Issue with 50G PAM4 C2M Specification

IEEE 802.3cd Task Force Meeting

Jan 11th, 2017

- ❑ In support of comment 116 against P802.3cd D1.1
- ❑ The IEEE 802.3bs C2M simulations have not demonstrated operation over 10.2 dB channel with max FEXT/NEXT

Crosstalk for C2M Test Case 3 and 5

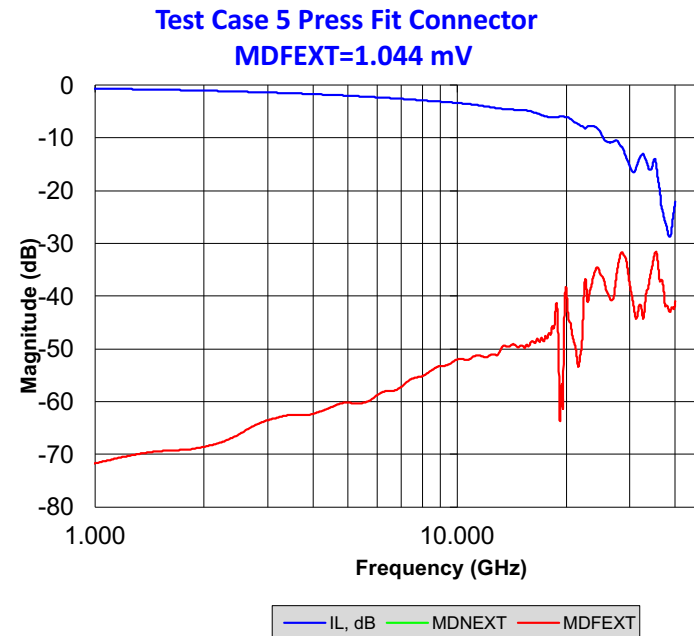
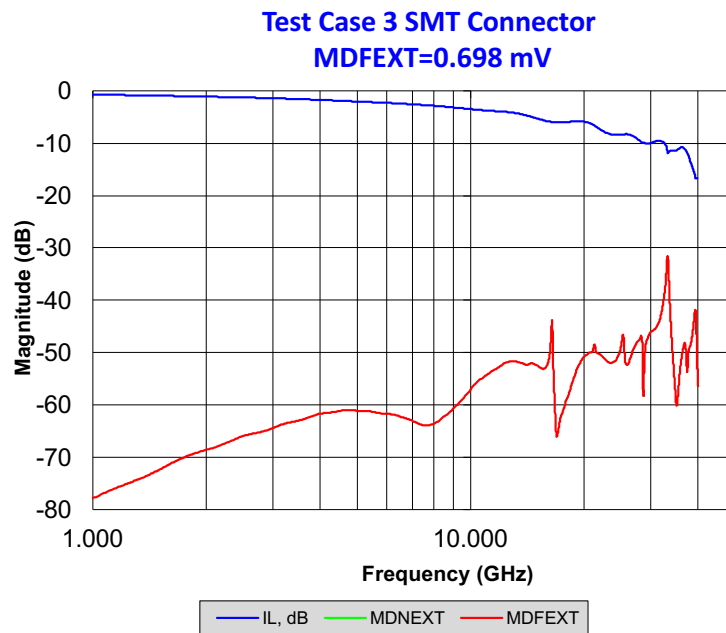
❑ Mated board had no NEXT and with excellent FEXT

- http://www.ieee802.org/3/bs/public/channel/TEC/shanbhag_3bs_01_1014.pdf
- C2M are based on channels with 5-7x lower crosstalk than mated board referenced currently!

Results with MTF Test Board

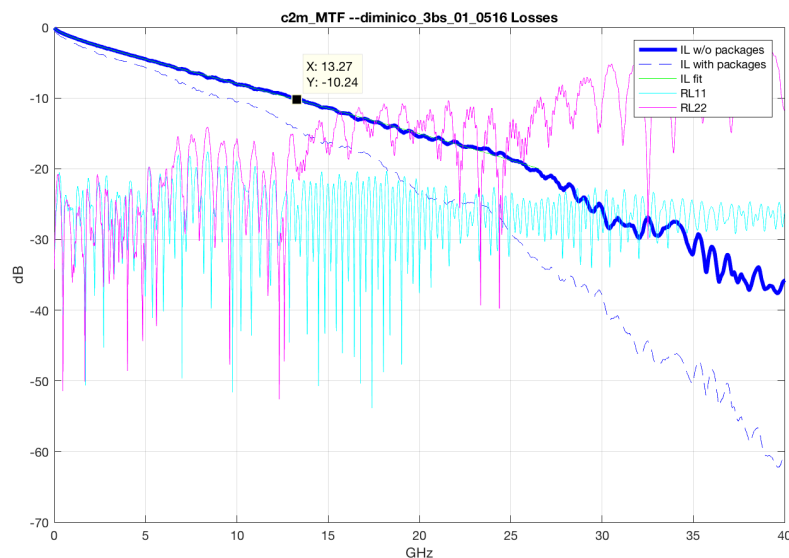
- TP1a response of the MTF test board + 150 mm trace has output VEO=32.2 mV without any crosstalk just passes the limit in CL 120.E!

VEO=32.2 mV, ICN=0 mV, Peak ISI=10.8 mV, MDFEXT Peak=0 mV

COM=5.13 dB

4" TE Stacked 50G Channel Meeting MTF

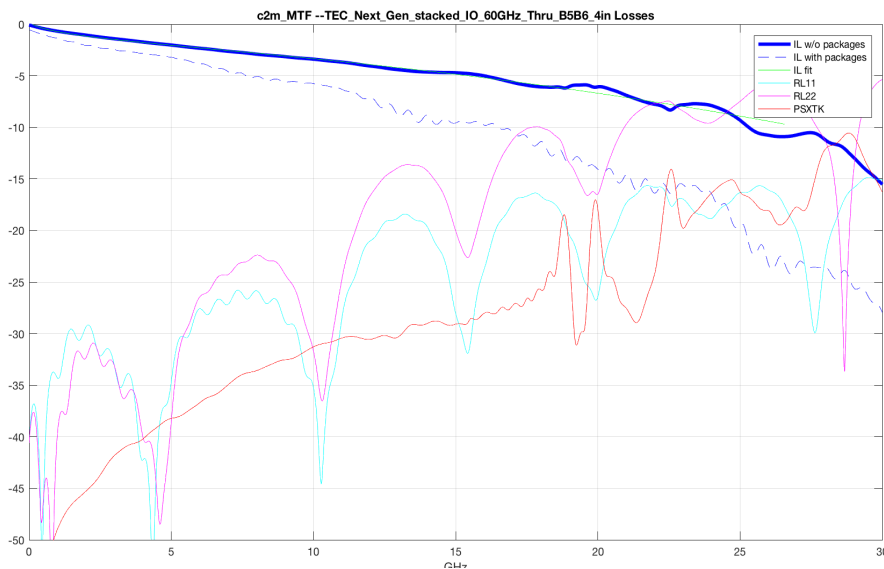
❑ Based on TE hypothetical connector with IL_Fit of 4.3 dB but having MDFEXT p-p=2.37 mV (MDFEXT RMS for BER 1E-5=2.37/4.26=0.56 mV)

- To account for worst case MDFEXT=4.8 mV and MDNEXT=1.8 mV (PSXT=5.13 mV RMS) A_fe in in COM was adjusted from 0.45 to 4.12 in order to get MDFEXT p-p of 21.84 mV equivalent to PSXT of 5.13 mV RMS per table 92-13
- http://www.ieee802.org/3/bs/public/channel/TEC/shanbhag_3bs_01_1014.pdf

VEO=42.5 mV, ICN=1.237 mV, Peak ISI=21.5 mV, MDFEXT Peak=21.88 mV COM=3.36 dB

10" TE Stacked 50G Channel

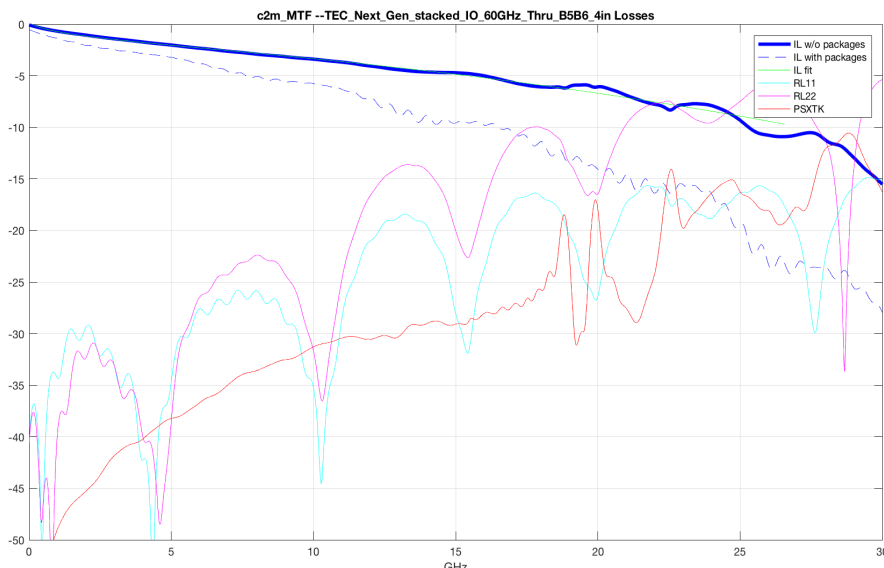
□ Based on TE hypothetical connector with IL_Fit of 8.8 dB shy of clause 120.E loss of 10.2 dB

- Since the 4" and 10" TE stack boards have similar construction with exception of one with longer trace, the calibrated A_{fe} crosstalk of the 4" board is used for the 10" board
- http://www.ieee802.org/3/bs/public/channel/TEC/shanbhag_3bs_01_1014.pdf

VEO=28.2 mV (failing), ICN=0.759 mV, Peak ISI=11.55 mV, MDFEXT
Peak=12.89 mV COM=3.65 dB

10" TE Stacked 50G Channel

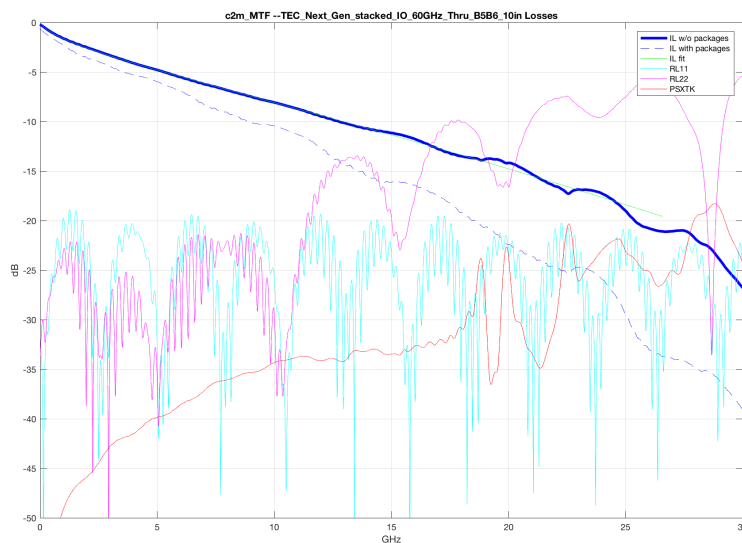
- Based on TE hypothetical connector with IL_Fit of 8.8 dB shy of clause 120.E loss of 10.2 dB, to increase the loss to 31 mm of PCB trace per clause 120 is added
 - Since the 4" and 10" board are similar with exception of the longer trace, calibrated A_{fe} crosstalk is kept at 4.14 for the 10" board+31 mm PCB trace

VEO=21.2 mV (failing), ICN=0.759 mV, Peak ISI=11.38 mV, MDFEXT

Peak=12.84 mV, COM=3.03 dB

QSFP MTF + Crosstalk from TE 4" Stacked

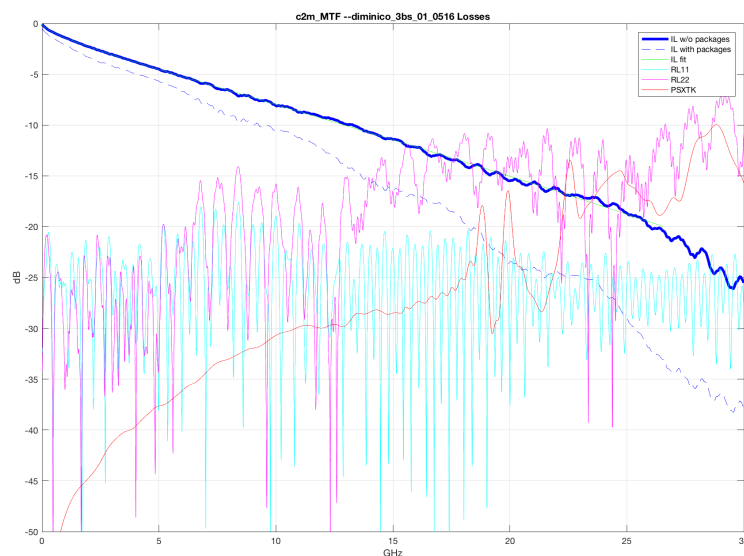
- ❑ QSFP MTF (diminico_3bs_01_0516.s4p) does not have any crosstalk data
 - TE 4" stacked with IL_Fit of ≈ 4.3 is used as the crosstalk source
 - 150 mm of PCB trace is added per clause 92 to increase the loss to 10.2 dB
 - The calibrated crosstalk source is $A_{fe}=4.14$

VEO=10.9 mV (failing), ICN=1.237 mV, Peak ISI=10.7 mV, MDFEXT Peak=20.87 mV COM=1.43 dB
